## LT-698 QX-5000 Mass. Code Upgrade Instruction Rev. 2

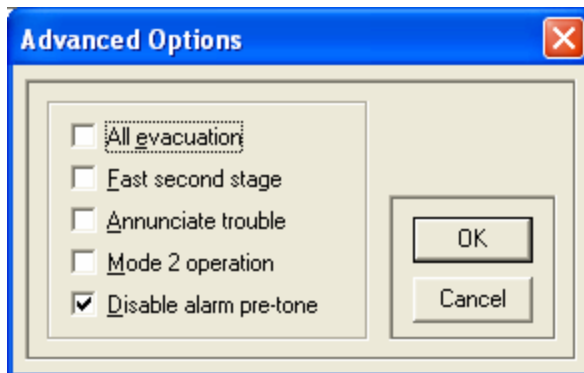
- 3.3. Double click 'Channel 2' to bring up the following window and enter the parameters as shown.
